STAFF REPORT

REFERENCE: RM070718V1 - Removal and Change of Conditions of RM070718
RM080608 - Land use consent

SUBJECT: **FAIRFIELD ORCHARDS - REPORT EP09/01/09** - Report prepared for hearing of 27 January 2009

SUBJECT: **SITE FAIRFIELD ORCHARDS LTD – UMUKURI ROAD
VARIATION TO EXISTING CONSENT**

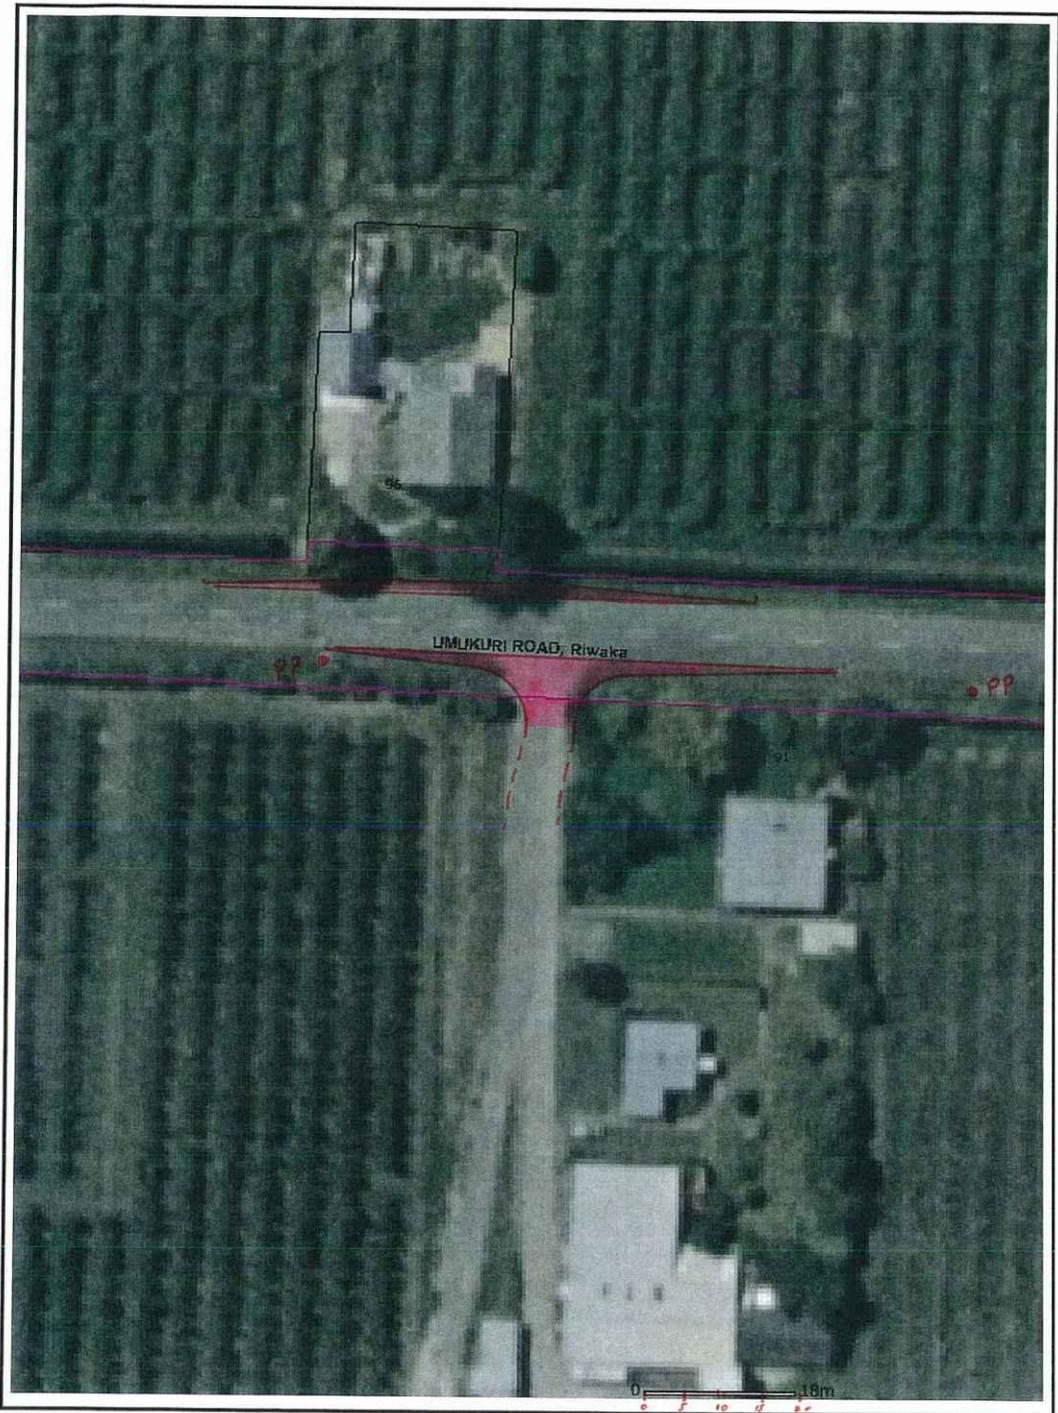
It is therefore appropriate that upgrading of both the eastern and western entrances be required as a condition of consent.

Diagram 2 of schedule 16.2c of the TRMP remains appropriate albeit with some slight modification to allow for the poles to remain that the applicant has been reluctant to relocate.

The two attached diagrams shown as "Eastern Entrance" and "Western Entrance" are recommended to mitigate adverse effects due to the increased traffic movements generated by the new buildings to be erected at both locations. These diagrams should form part of the consent conditions if the application is approved.

8. Within three months of the granting of this consent the two access points shall be upgraded to comply with the diagrams labelled 'eastern entrance' and 'western entrance' in Council's Development Officer's memorandum which forms Appendix One of this report.

Cool Store Detail

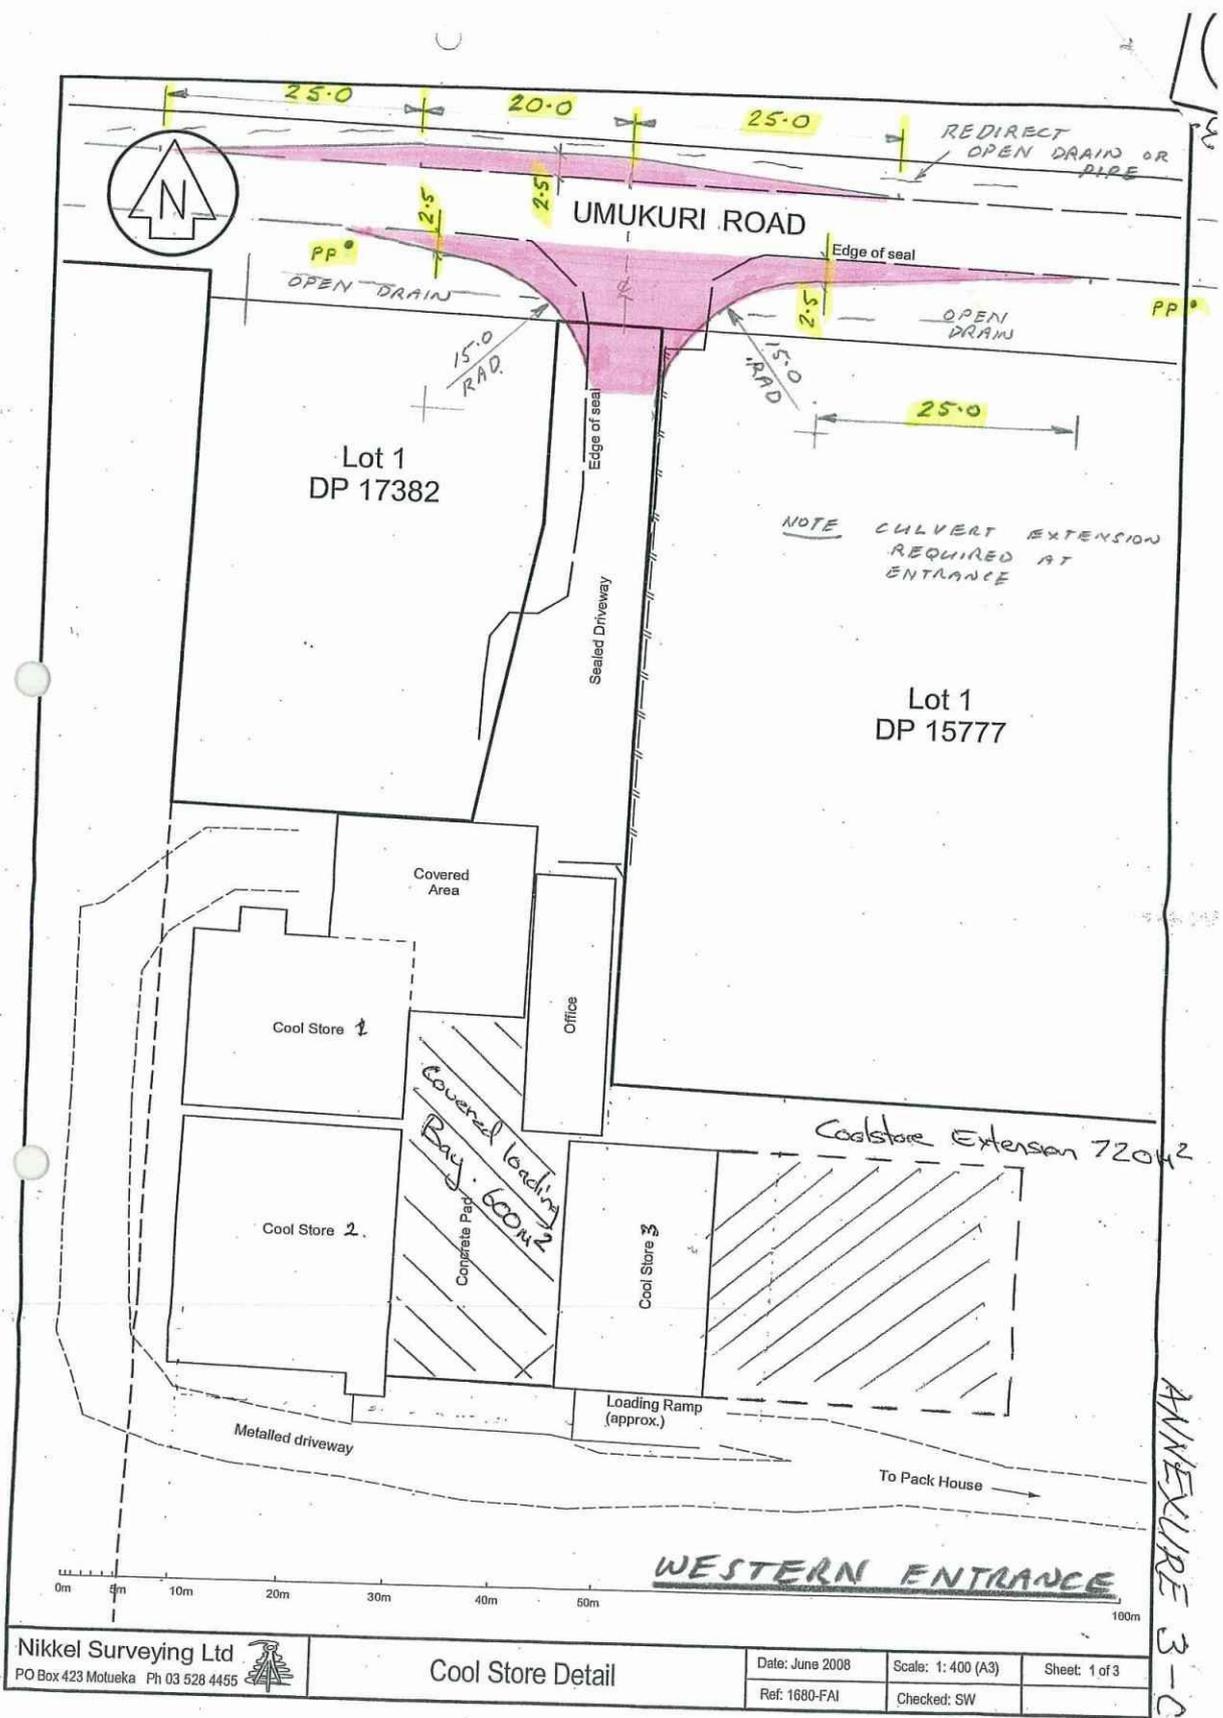
Land use consent to extend the existing covered loading bay by approximately 480m² at the rear of the existing packhouse and add a new 200m² coolstore adjoining the south wall of the existing covered loading bay on the eastern part of the site.

Land use consent to increase the size of the existing coolstore number 3 by adding another 720m² to its eastern end and cover the existing concrete yard loading/access pad with a canopy between coolstores 1, 2 and 3 as shown in Annexure 3 of the application.

The addition to coolstore 3 is in behind an adjoining property. The owner/occupier of this property has submitted on this application and has noted that they agree with the proposal but would like any compressors associated with the extension to be placed at the southern end of the building facing the applicant's property so as to mitigate any potential noise effects. I agree that this request will mitigate potential noise and have therefore recommended it as a condition of consent.

3. Any ventilation from the new coolstore or compressors associated with the new coolstore shall be located on the southern side of the building.
